Airport Moving Map Alert

Subject: **Luxor, Egypt**
Luxor Intl (HELX)
Cycle 2611 and 2612

Apron 1 and Apron 2 layouts incorrect.

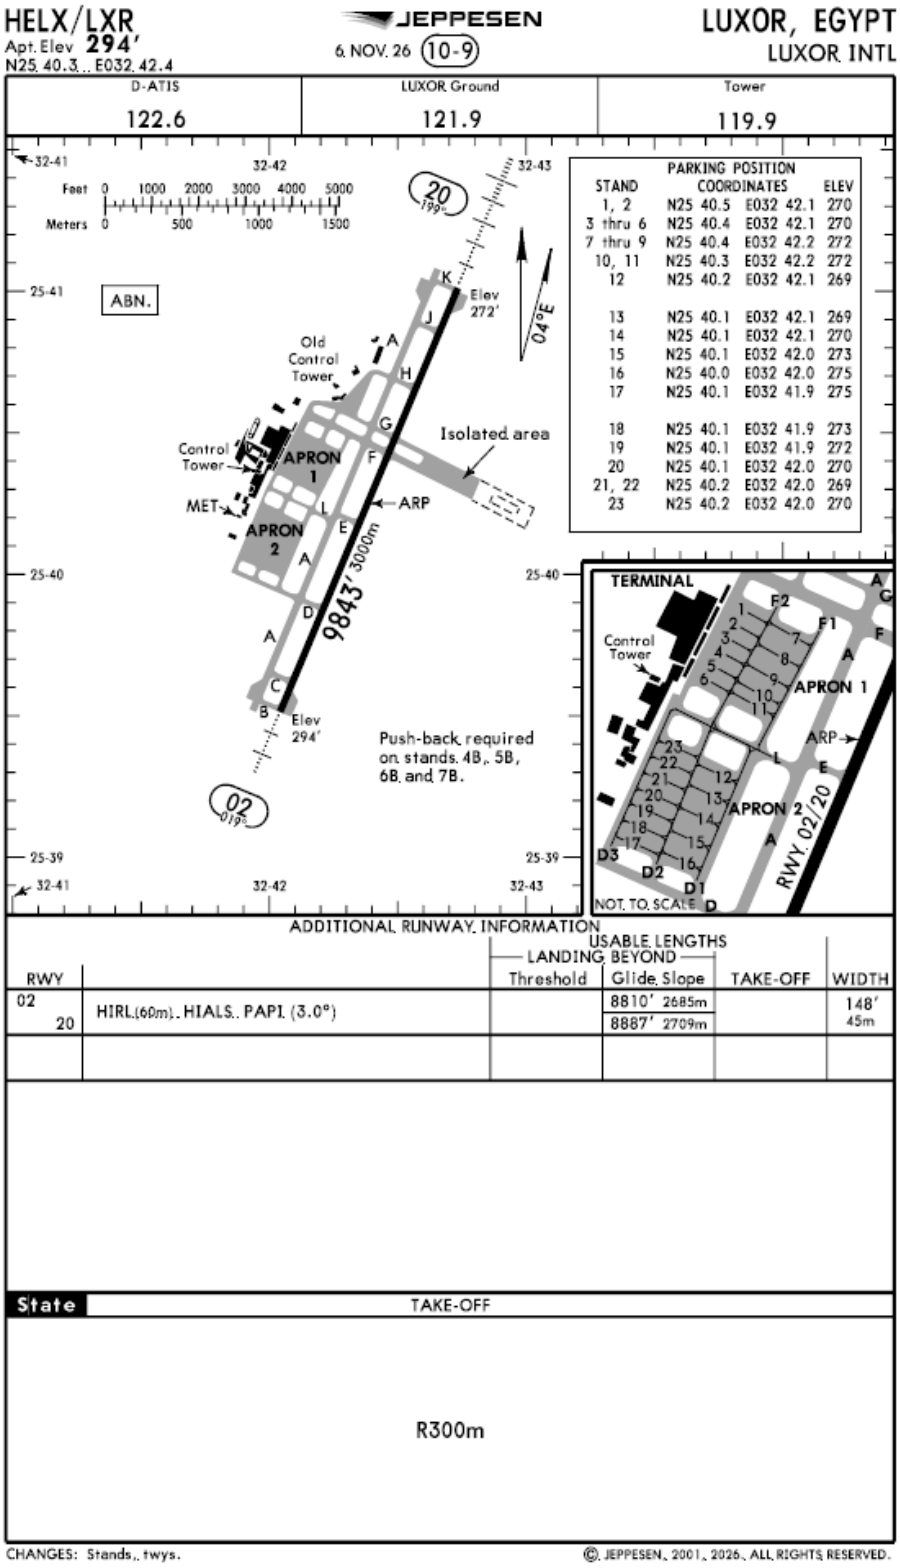
As a result, the following changes are not reflected in cycle 2611 and 2612 data:

- Parking Stands 4A to 9A and 4B to 7B on Apron 1 are replaced by Parking Stands 1 to 11
- Parking Stands 10A to 14A on Apron 2 are renamed to 12 to 16 respectively
- Parking Stands 8B to 14B on Apron 2 are renamed to 23 to 17 respectively
- TWYs L1 and L2 located north of TWY L are renamed to F1 and F2
- TWYs L1 and L3 located south of TWY L are renamed to D1 and D2

Revised data will appear in Jeppesen Airport Moving Map and A816 formatted data for cycle 2613, effective 24 December 2026. Until then this Alert will be posted on the Jeppesen Web site: Notices and Alerts. Please refer to the local NOTAMs and attached Luxor, Egypt (HELX) 10-9 chart dated 6 NOV 2026 for valid information.
